City of Surrey
PLANNING & DEVELOPMENT REPORT

File: 7912-0218-00

Planning Report Date: December 10, 2012

- **Rezoning** from RA to RF-9 and RF-12
- **Development Variance Permit**

**PROPOSED SUBDIVISION PLAN OF LOT 3,
SECTION 10, TOWNSHIP 2, N.W.D. PLAN 20412.**

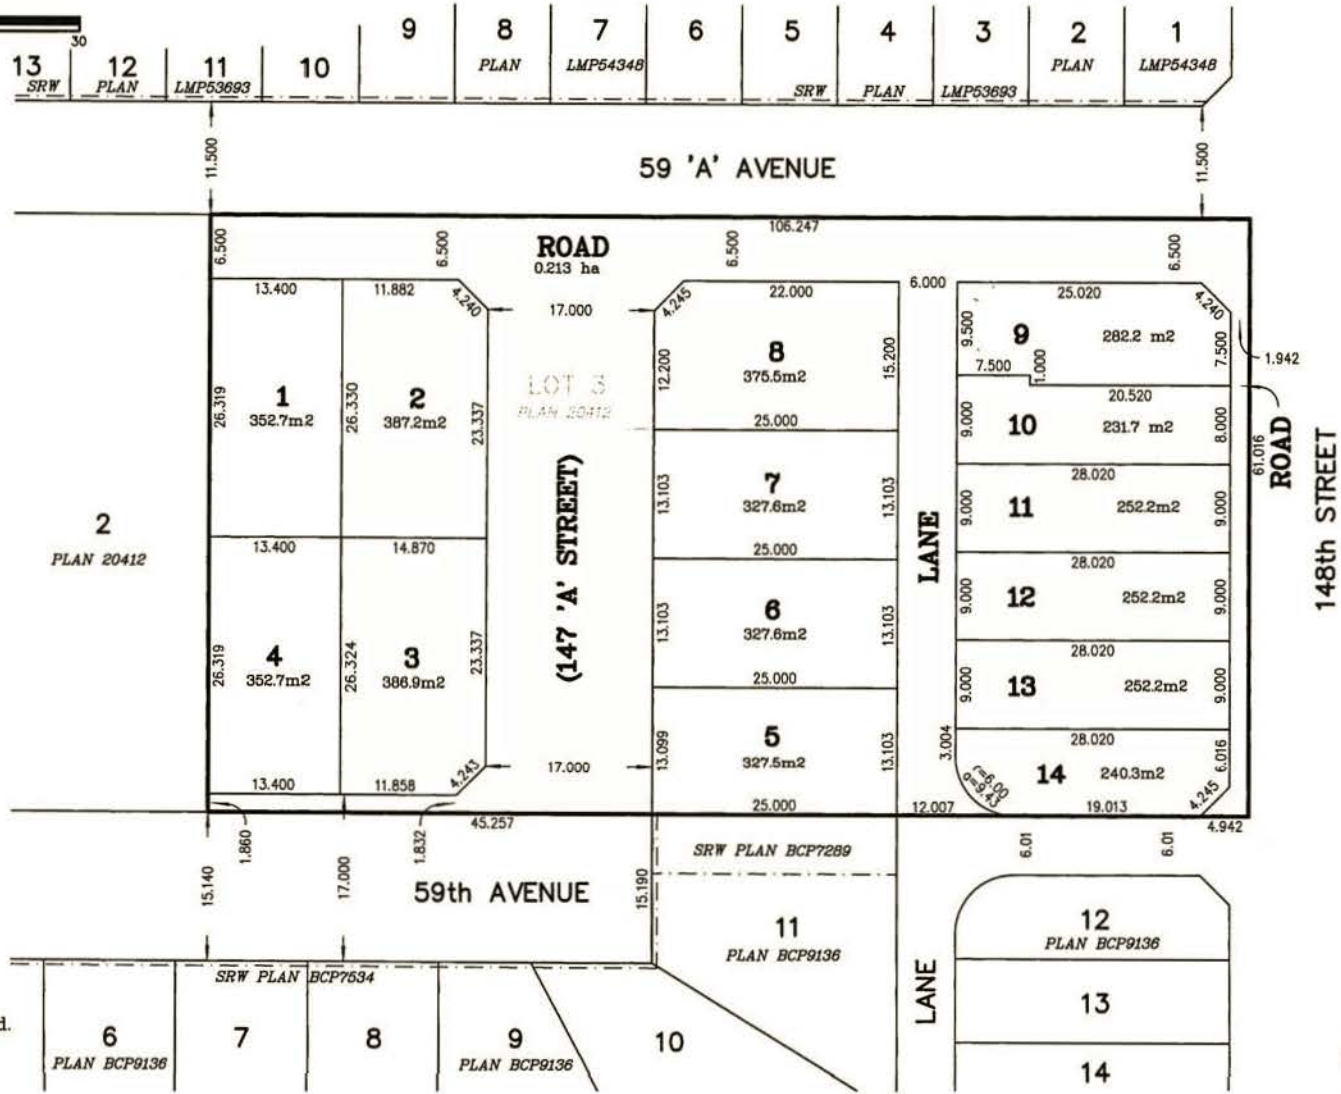
- The applicant proposes to rezone the subject property to RF-9 and RF-12 to allow subdivision into 14 lots, resulting in a net density of 8.75 units per acre. (Appendix II).
- Staff have concerns over the lack of tree retention with the proposal and have asked the applicant to adjust the proposed subdivision layout by reducing the number of lots to 13 in order to accommodate tree retention. Alternate layouts provided did not accommodate any further retention of trees, in addition to proposing unnecessary cul-de-sacs and awkwardly shaped lots.

- Staff have asked the applicant to change the proposed layout such that Lots 9, 10 and 11 be reconfigured into two RF-12 lots fronting 148th Street in order to accommodate these trees. Proposed Lots 13 – 14 would remain RF-9, as proposed in the attached layout.

- Proposed Lots 1 – 4 meet the minimum width, depth and area requirements of the Type I RF-12 zone. Proposed Lots 5 – 8 meet the minimum width and depth requirements of the Type I RF-12 zone, however a development variance permit for lot depth is required. The depth of these lots is limited by the road layout established by development application 7901-0206-00 to the south.
- Proposed Lots 9 – 14 meet the minimum width, depth, and area requirements of the RF-9 zone. A slight jog in the property line between lots 9 and 10 is proposed to accommodate 3 parking spots on Lot 10, thus allowing for a secondary suite.
- The proposed rezoning and lot sizing/configuration is consistent with the direction provided in the South Newton NCP as well as the pattern established in the surrounding area.

The Planning & Development Department recommends that this application be referred back to staff in order to work with the applicant to pursue a layout that accommodates the retention of on-site trees.

The Planning & Development Department recommends that this application be referred back to staff in order to work with the applicant to find a layout that accommodates the retention of on-site trees.

TITLE
 PLAN VIEW
 TREE LOCATION PLAN
 TREE RETENTION PLAN
 14 LOT SUBDIVISION
 5927 - 148 STREET
 SURREY, B.C.

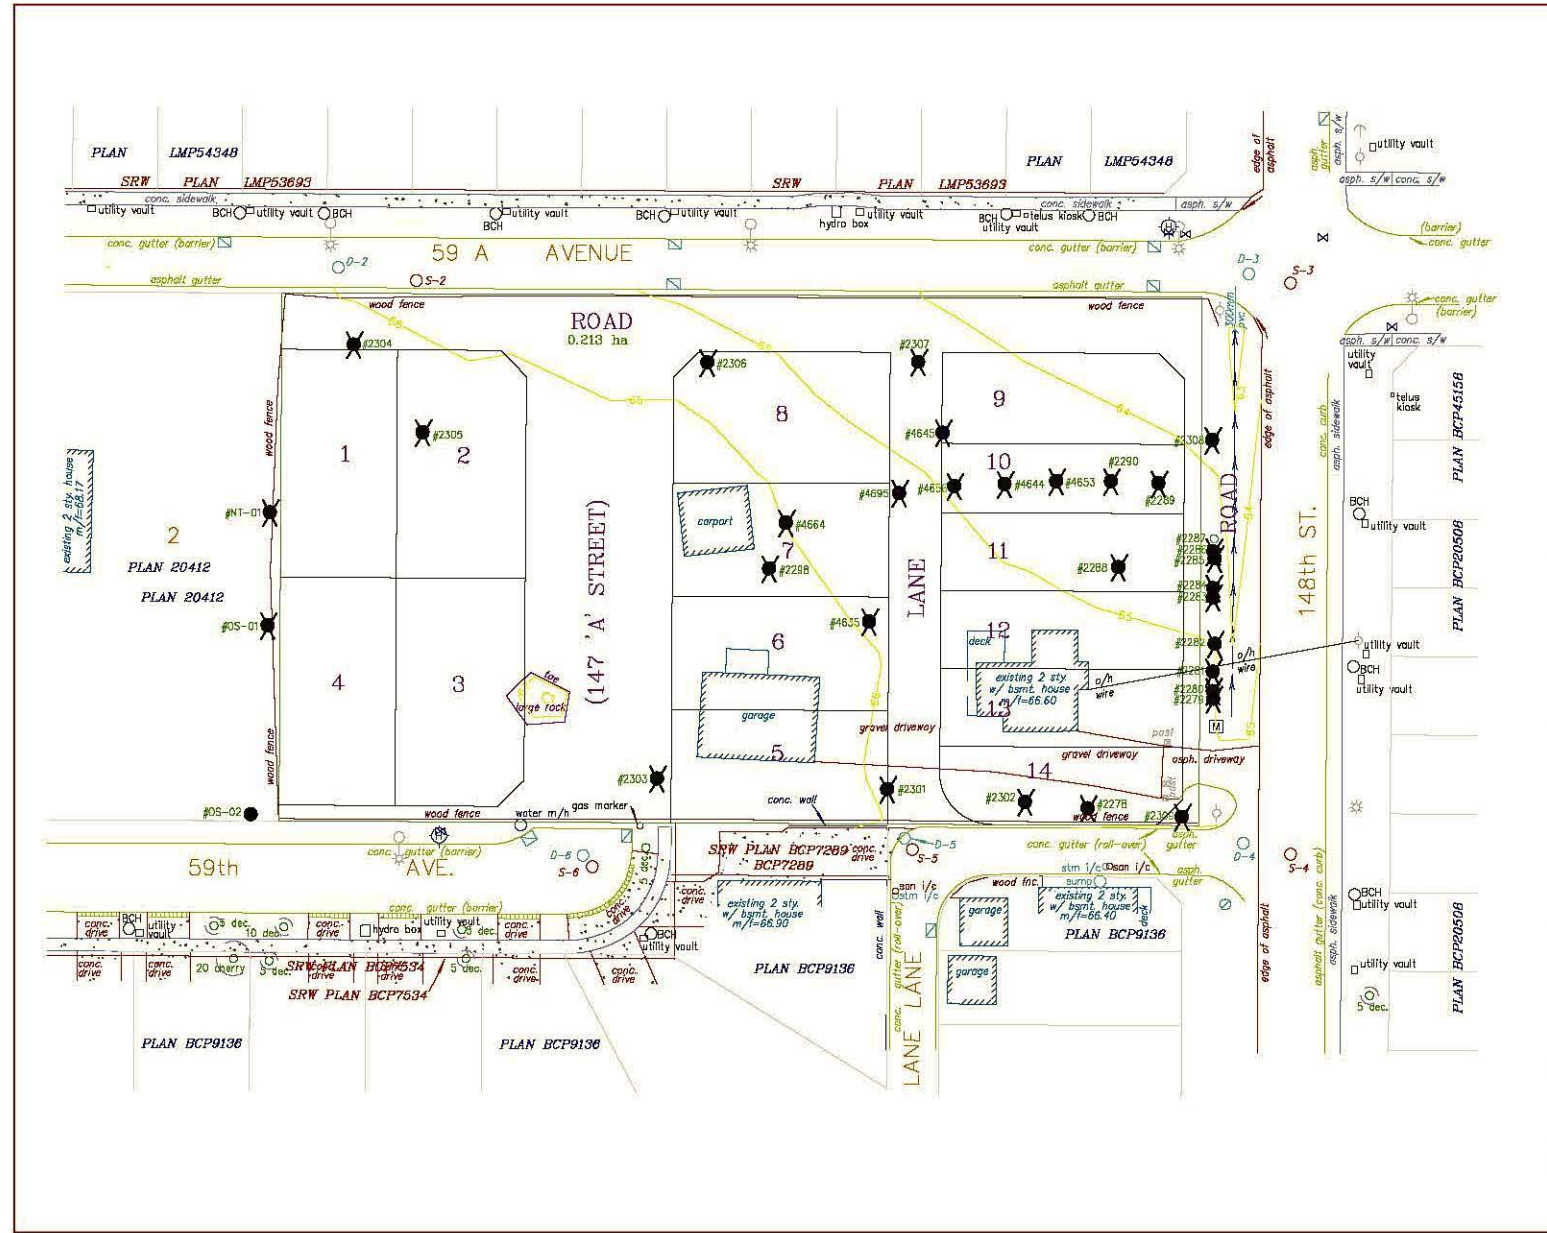
- Four Douglas Firs oriented east-west (on proposed Lot 10) are good candidates for retention, as per the supplied arborist report (Trees #4644, #4659, #2290, #2289 - Appendix VII). These four trees have an average trunk diameter of 44cm, are arranged in a well-spaced row, and are in good health with an overall condition of 'fair'.

- The small lot configuration of the subject property severely inhibits the potential for tree retention. All of the trees onsite are affected by either proposed road right-of-ways or building excavation areas. Staff and the applicant have explored the possibility of

retaining some trees; however, there are no opportunities to retain trees using the proposed layout without severely compromising either tree health, building size, or both.

- The neighbouring property owner has agreed to the removal of the 2 off-site trees at the applicant's expense.
- With the current proposal, 56 replacement trees are required on the site as per the City's Tree Protection Bylaw. The applicant proposes 27 replacements as well as an \$8,700 contribution to the City Green Fund to address the deficit of 29 replacement trees. This yields an average of 1.9 total trees per new lot, consistent with the City's standards for lots of this size.
